**CORRESPONDENCE COVER SHEET  
WASTE PERMITS DIVISION  
TEXAS COMMISSION ON ENVIRONMENTAL QUALITY**

Date: April 25, 2019  
 Facility Name: City of Kingsville Landfill  
 Permit or Registration No.: MSW 235-C

Re: City of Kingsville Landfill – Kleberg County  
Municipal Solid Waste (MSW) - Permit No. 235C  
Permit Amendment Application – Notice of Deficiency  
Tracking No. 23301130, 23458984, and 24040819; RN102334570/CN600674246

On behalf of the City of Kingsville and in response to the Texas Commission on Environmental Quality's (TCEQ) March 27, 2019 Notice of Deficiency (NOD) letter, we hereby submit the enclosed response regarding the Permit Amendment Application for the above referenced MSW facility.

**FIGURE:**  
**III.5-D.1**

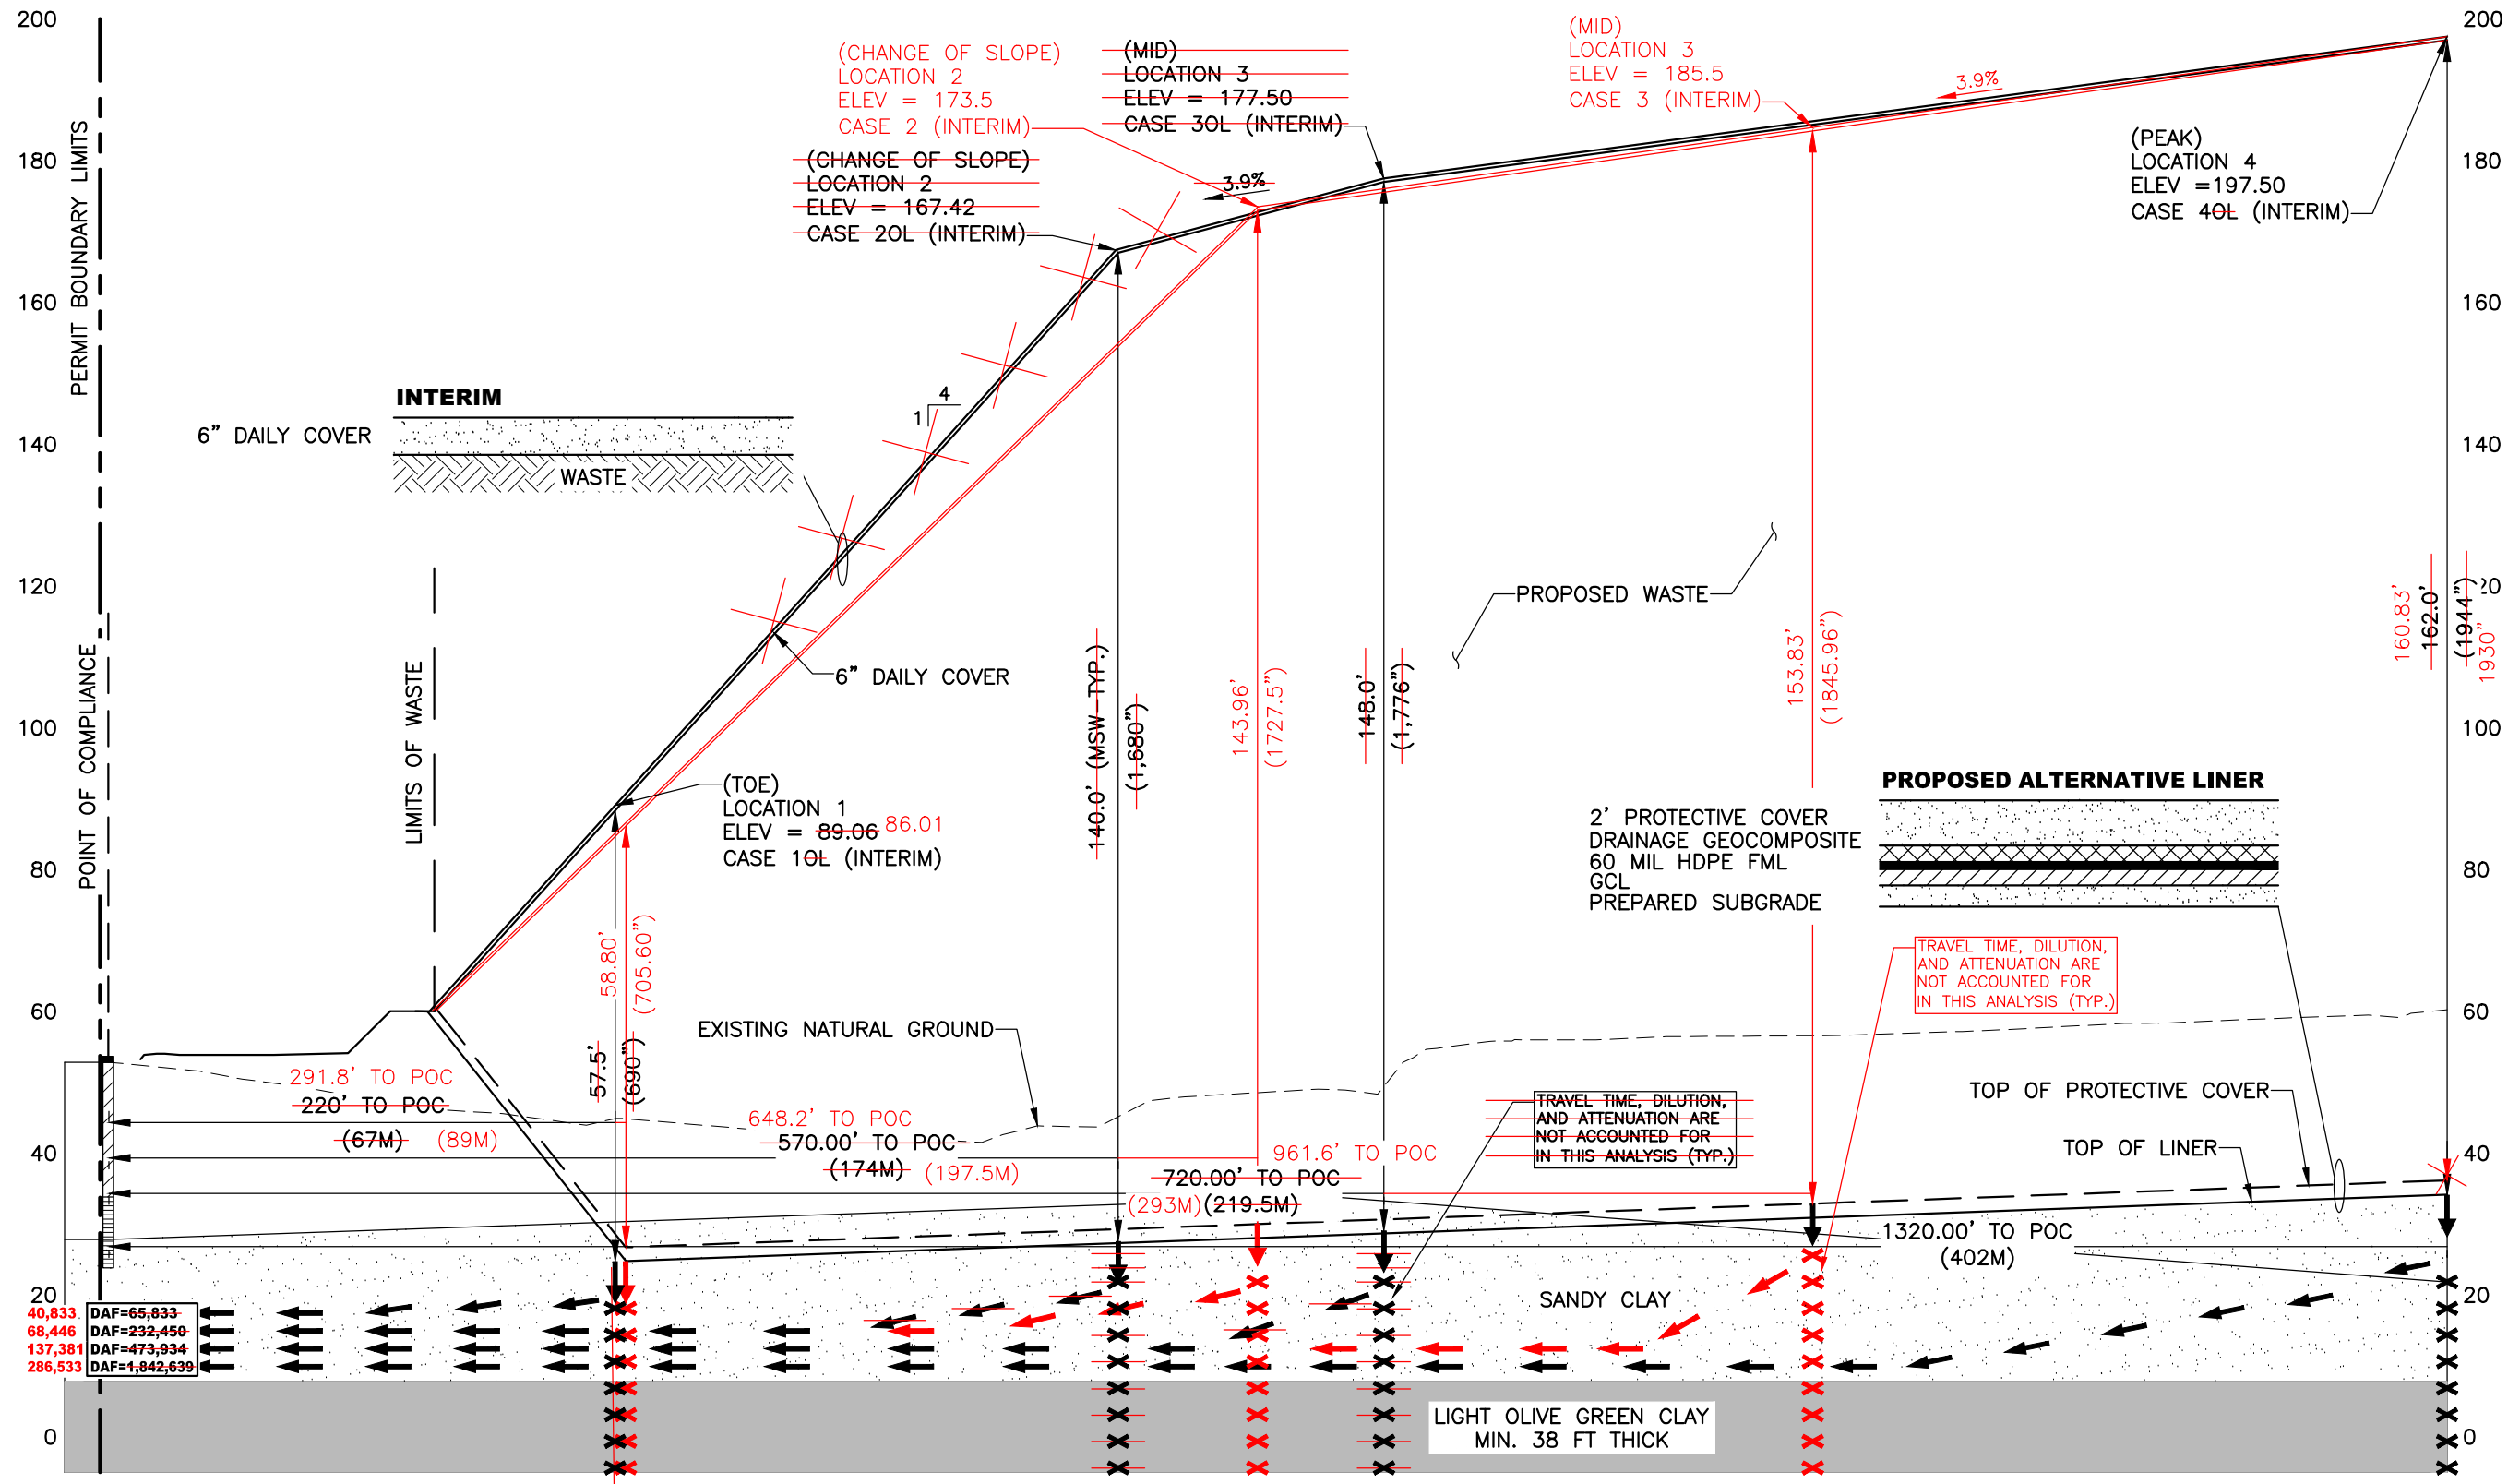
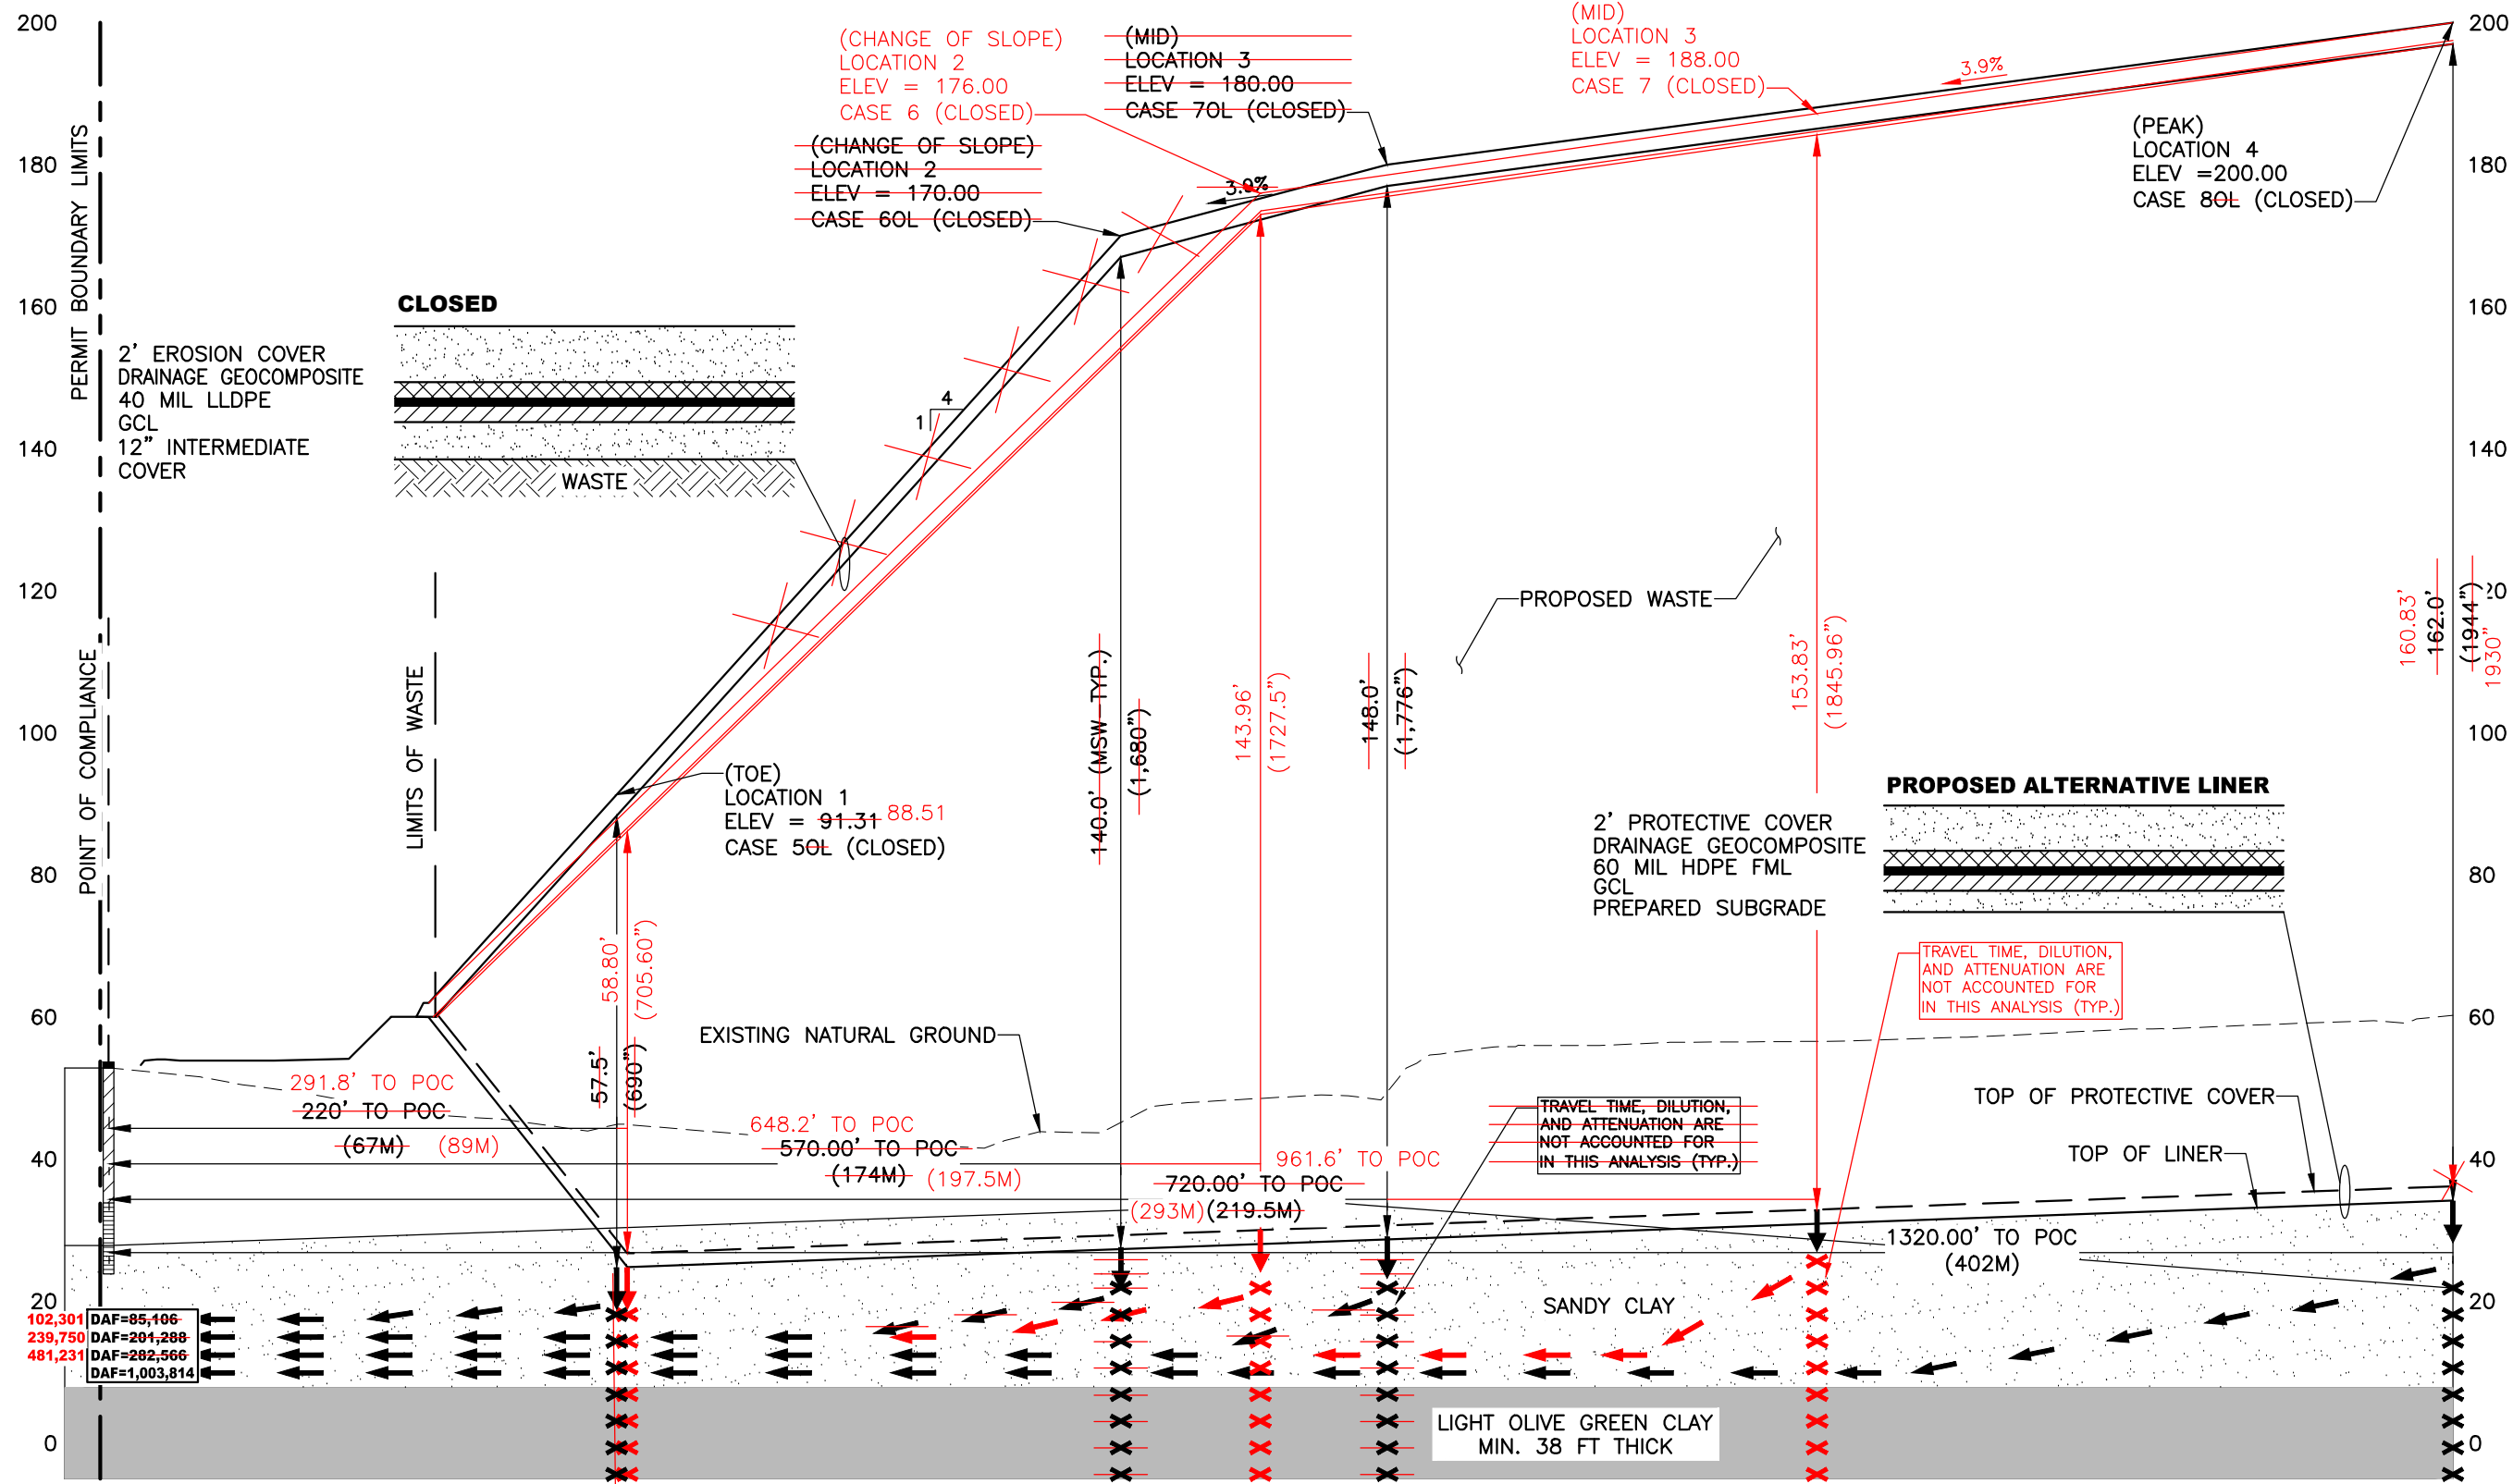
NT21	379	Part III	330.335	Vol. 4, Part III, Att. 5, Figs III.5-D.1 through D.4	Incorrect	Correct the labels and the distance to POC for the cases that do not include overliner. Correct the DAF values for the non-overliner interim case.	The labels and the distance to POC for the cases that do not include overliner have been corrected. This affects Figures III.5-D.1 and D.2. It does not affect overliner Figures III.5-D.3 and D.4. The DAF values for the non-overliner interim and closed landfill conditions have been corrected as shown in the figures and Section 4 Point of Compliance Demonstration Results in Part III, Attachment 5, p.g.-7 and Appendix D, p.g.-1, Calculations of the Dilution Attenuation Factor. The corrections to the distance to POC resulted in slight corrections to the MSW thickness parameters in the HELP Model as shown in corrected Appendices B.3-B.10 used to determine the infiltration rate through the liner for use in MULTIMED as corrected and shown in Part III, Attachment 5, Appendix B.1, p.g.-1, HELP Model/MULTIMED Model-Summary of Cases 1-8 and Appendix B.2, p.g.-1, HELP Model Case Summary. However, this correction did not change the infiltration rate used for the various cases in MULTIMED as shown in Appendix C.3, p.g.-1, MULTIMED Source-Specific Data. These infiltration rates were used to run new MULTIMED models with the corrected lengths to POC as shown in Appendix F.1 MULTIMED Output for Alternative Liner Interim Case 1-Location 1, Appendix F.2 MULTIMED Output for Alternative Liner Interim Case 2-Location 2, Appendix F.3 MULTIMED Output for Alternative Liner Interim Case 3-Location 3, Appendix F.5 MULTIMED Output for Alternative Liner Closed Case 5-Location 1, Appendix F.6 MULTIMED Output for Alternative Liner Closed Case 6-Location 2, and Appendix F.7 MULTIMED Output for Alternative Liner Closed Case 7-Location 3. Note, new MULTIMED models were not run for Case 4 and Case 8 because the infiltration rate and length to POC did not change.
